**re:** **Excavation, Grading and Drainage Plan Review**  
**Proposed Residential Development**  
**100 Steacie Drive, Ottawa, Ontario**

**file:** PG5788-MEMO.03 Revision 2

Project	PG5788 - 100 Steacie Drive		
Group	Section A - Static Analysis		
Drawn By	PT	Company	Brigil
Date	04/2026	File Name	Slope Stability Assessment

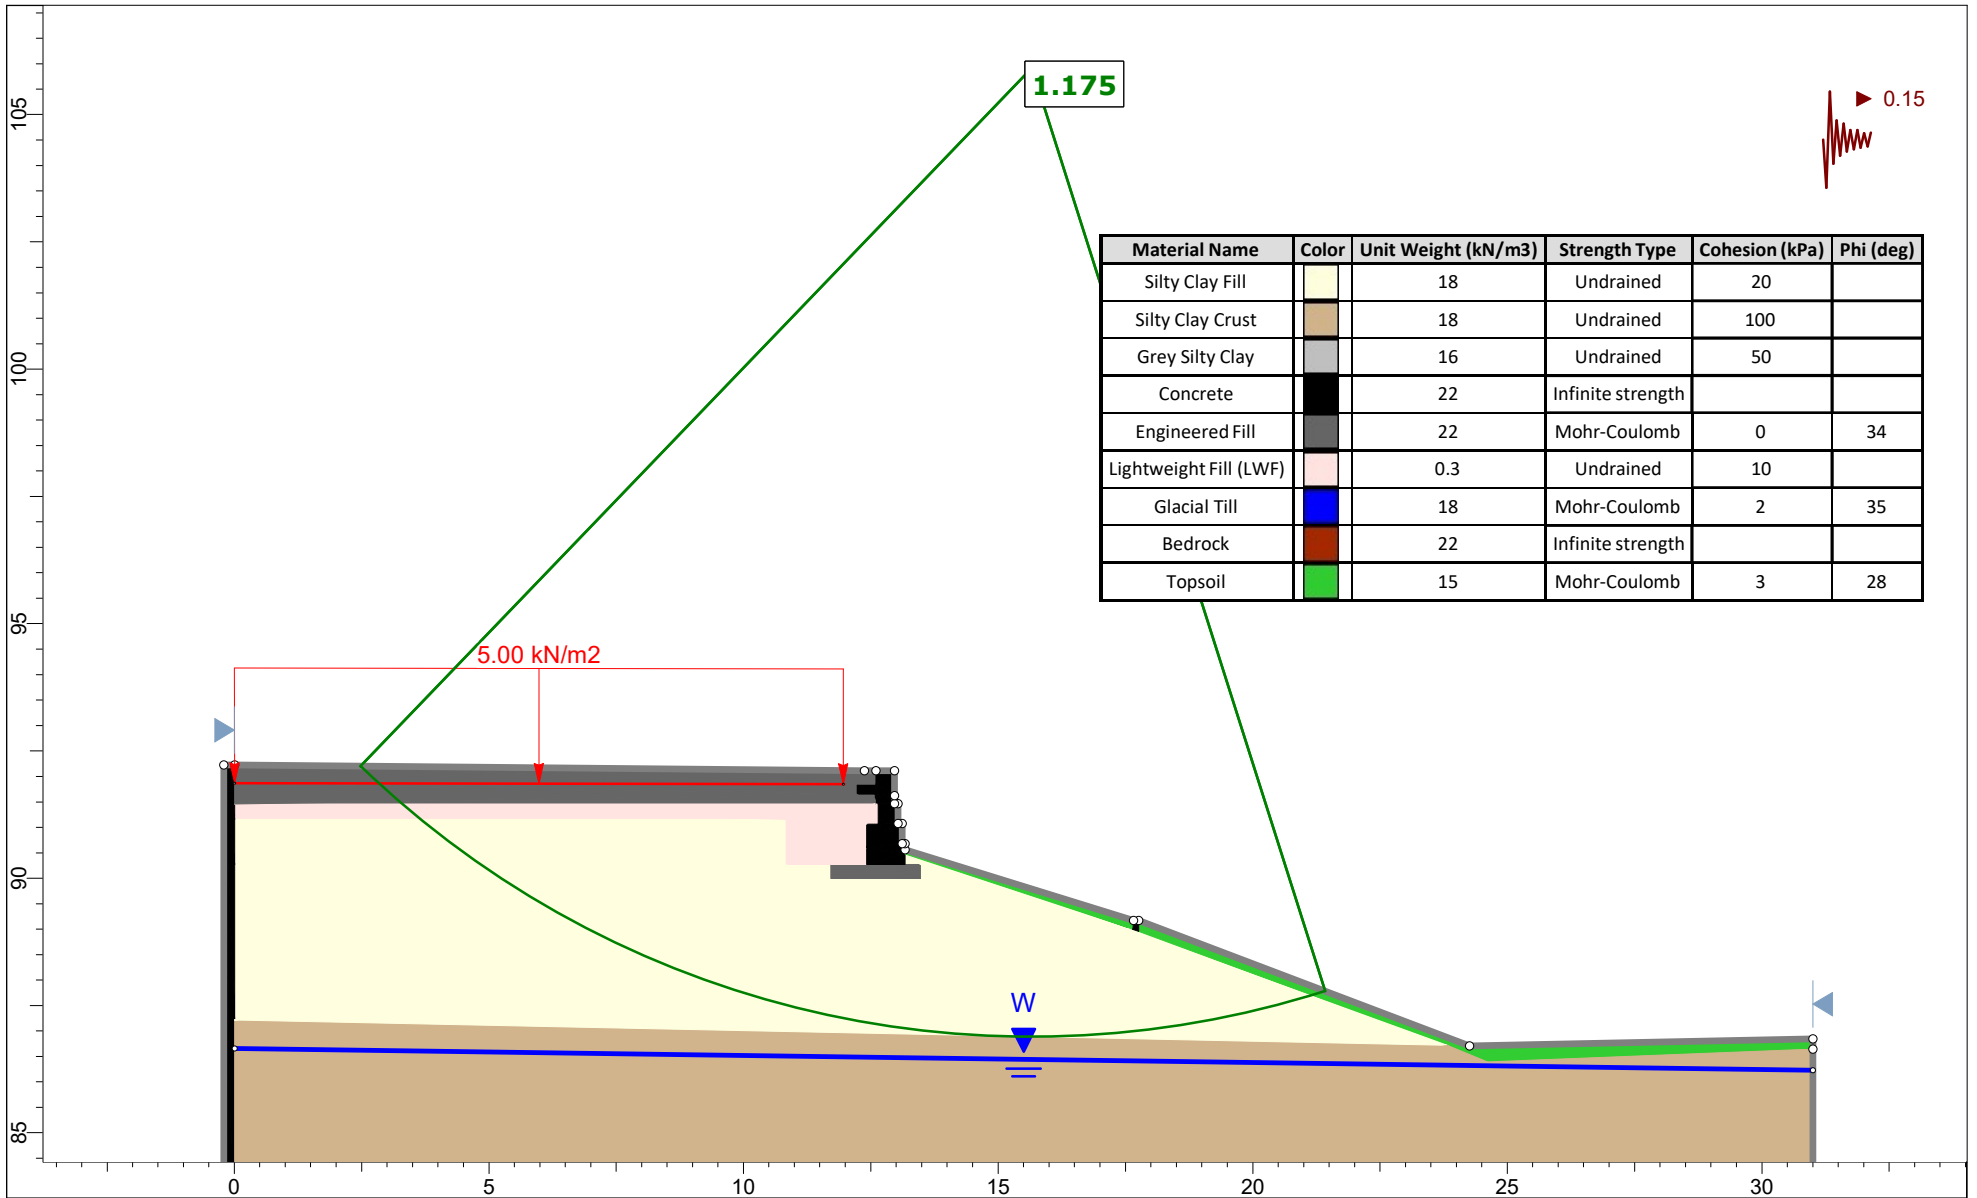
The static and seismic analysis results for slope cross-section A are presented in the figures attached below. In summary, the factor of safety for the slope was more than 1.5 under static conditions and more than 1.1 under seismic conditions.

**LIGHTWEIGHT FILL DETAIL**

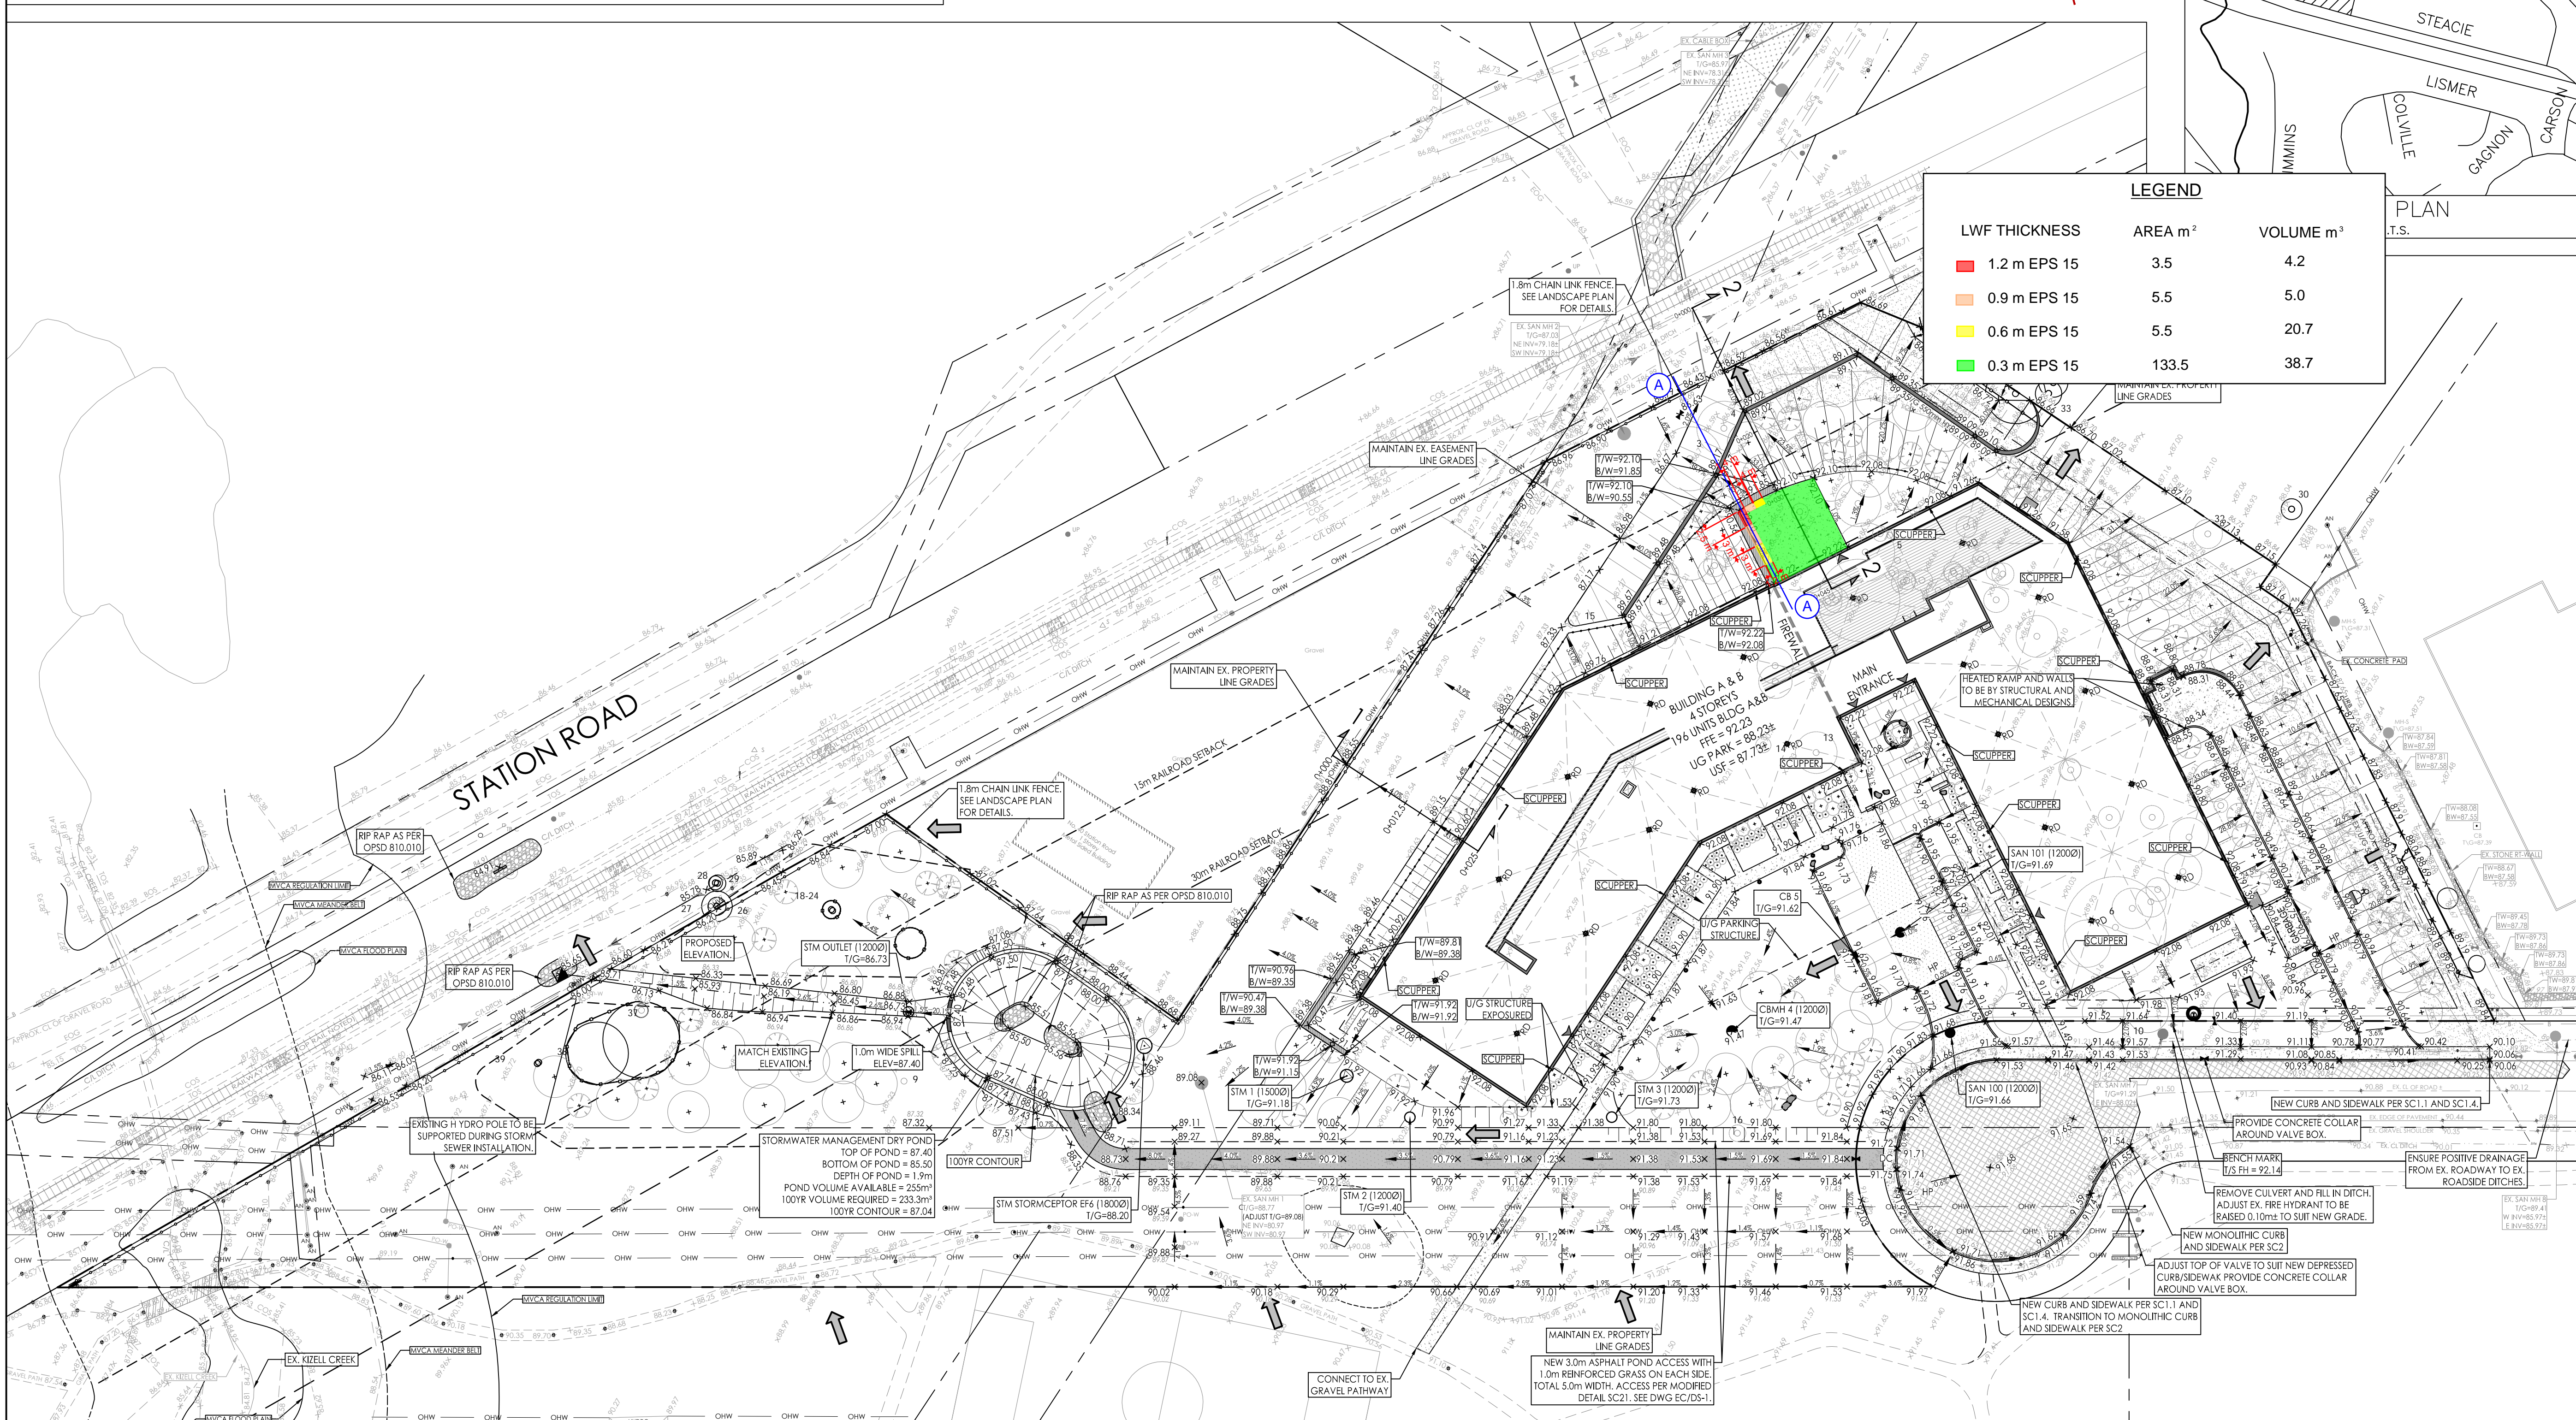
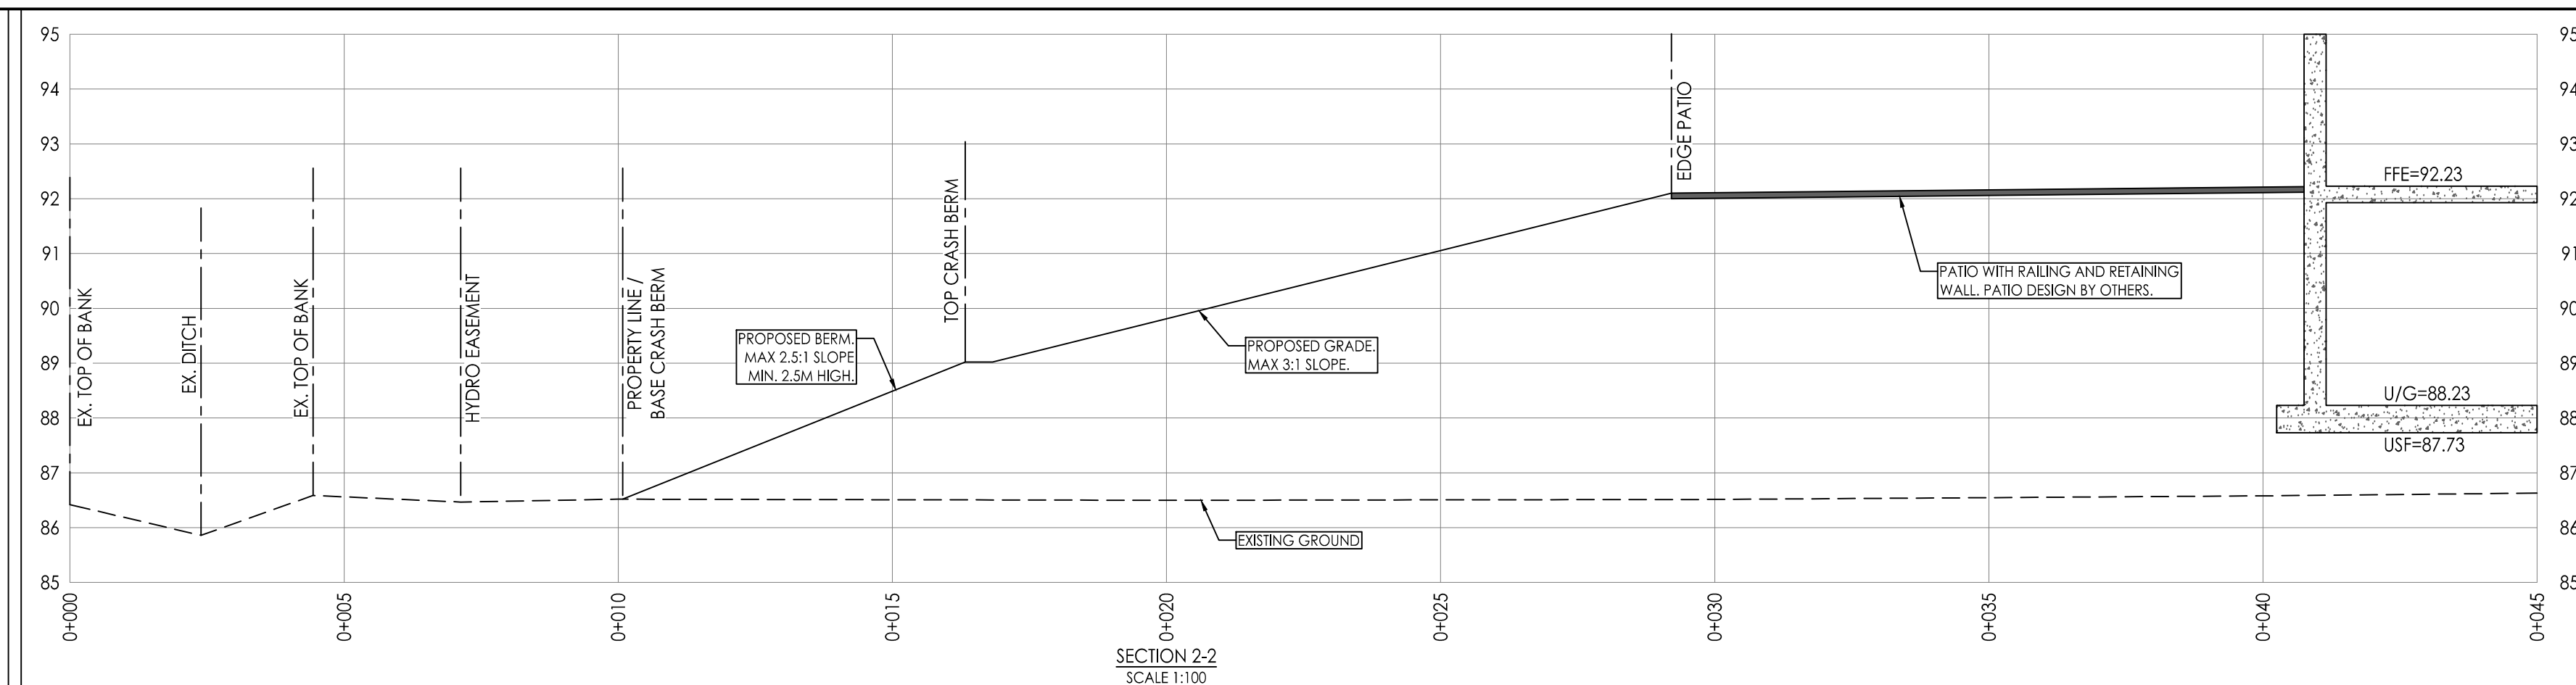
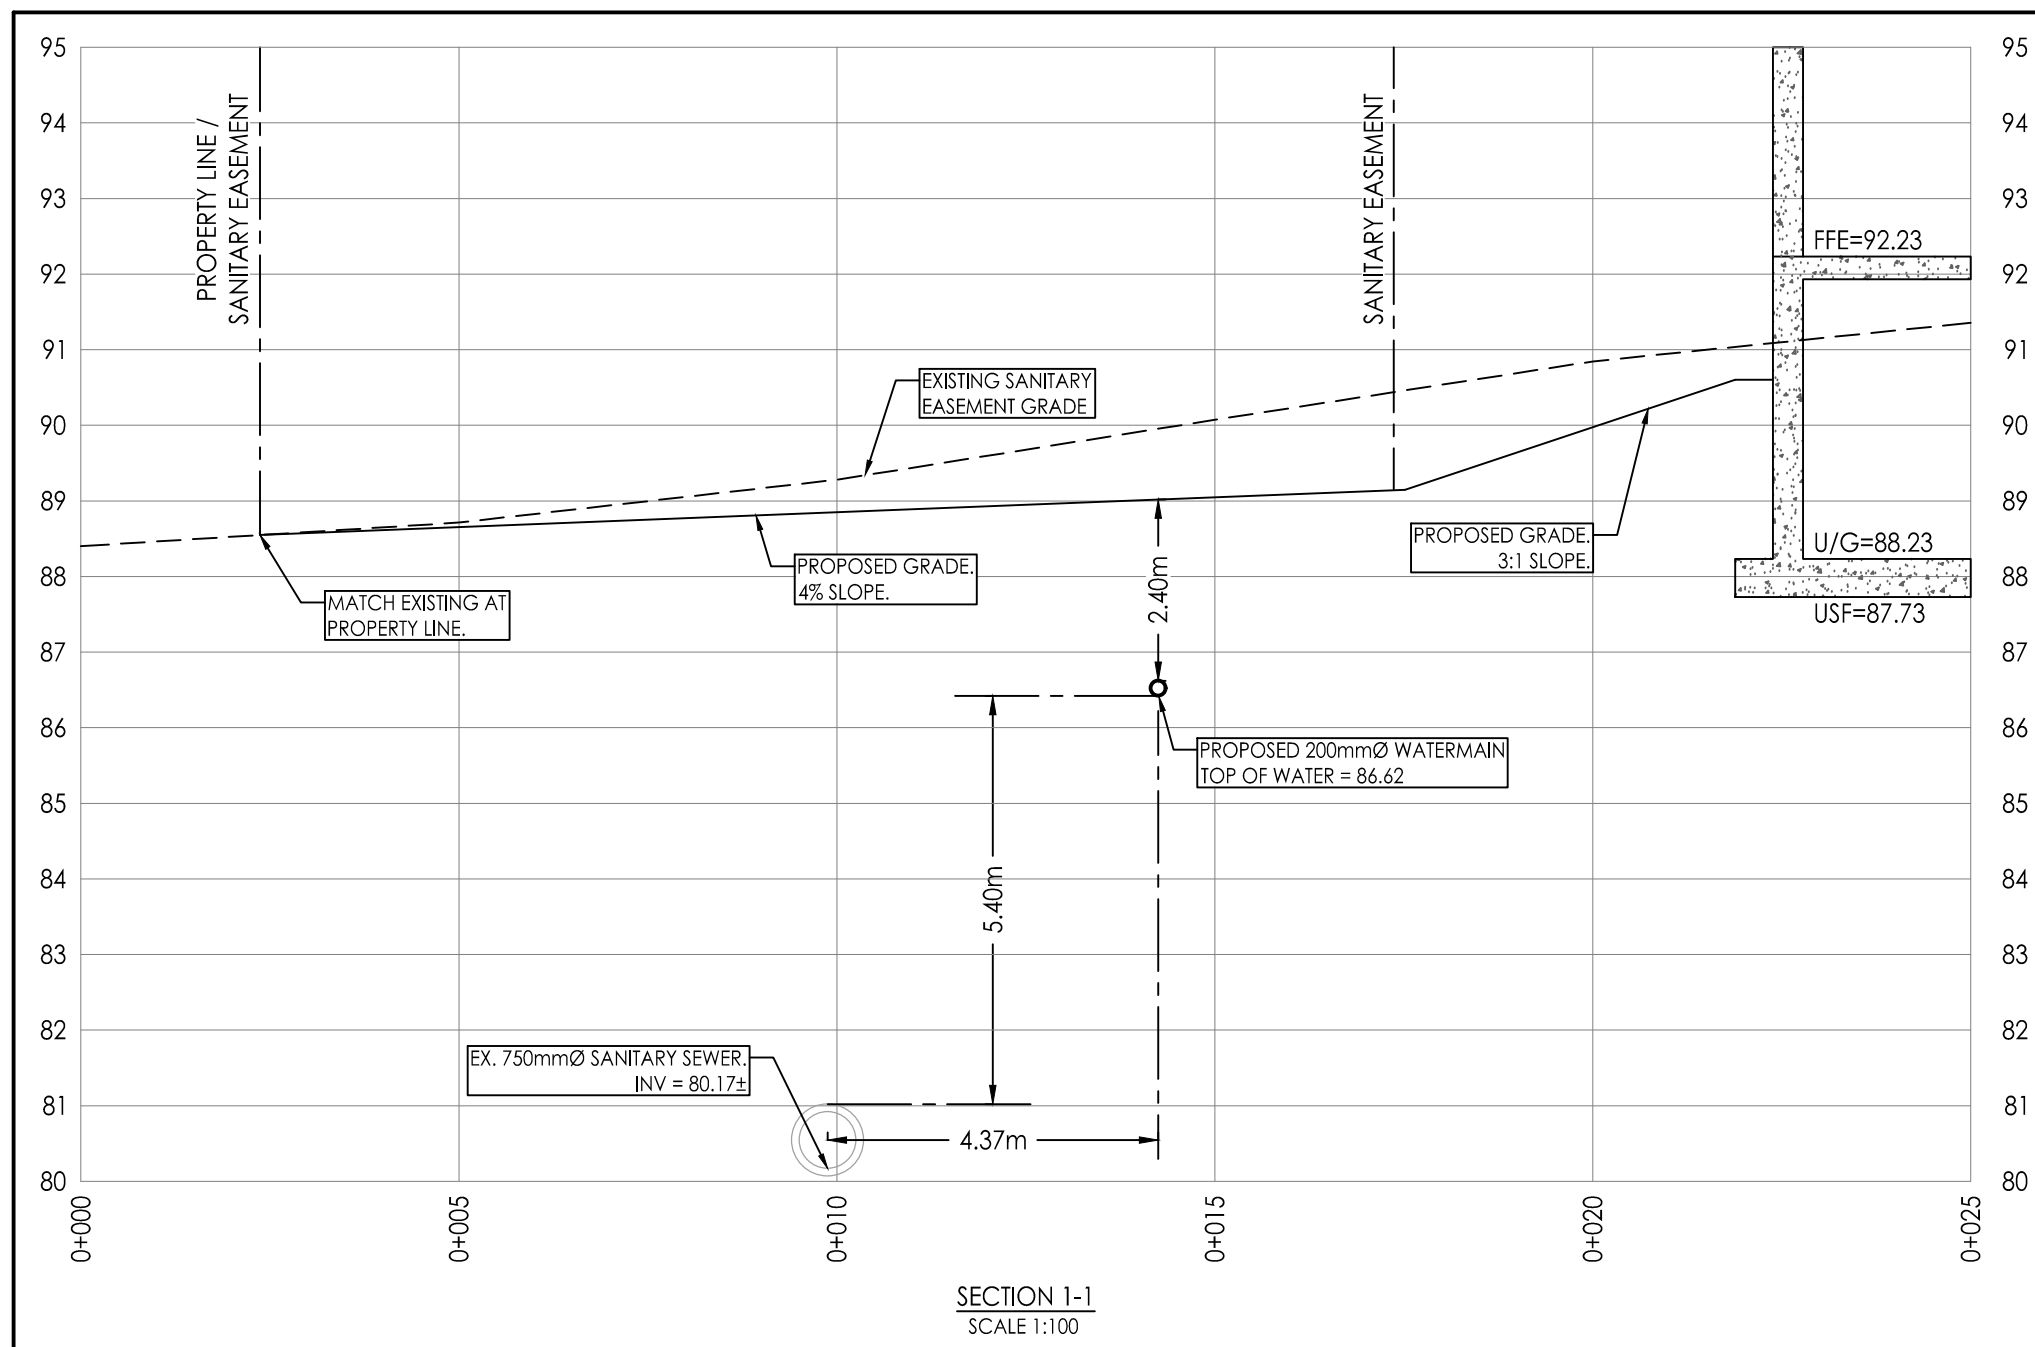
To mitigate the settlement in the landscaping areas, some lightweight (LWF) will be required surrounding the proposed retaining walls and the hardscaped areas located along the north and northeast side of the building. The LWF material should consist of EPS 15.

Reference should be made to the attached grading plan markup and LWF details attached below for the required LWF thickness within the respective areas.

It is not recommended to plant medium to large trees directly above the LWF EPS. The EPS should be covered with a polyethylene sheet and surrounded with a non-woven geotextile such as Terrafix 270R.

A minimum of 200 mm of OPSS Granular A should be placed above the LWF under the hardscaped areas and a minimum 200 mm of approved fill material and a minimum of 100 mm of topsoil should be placed under landscaped areas.
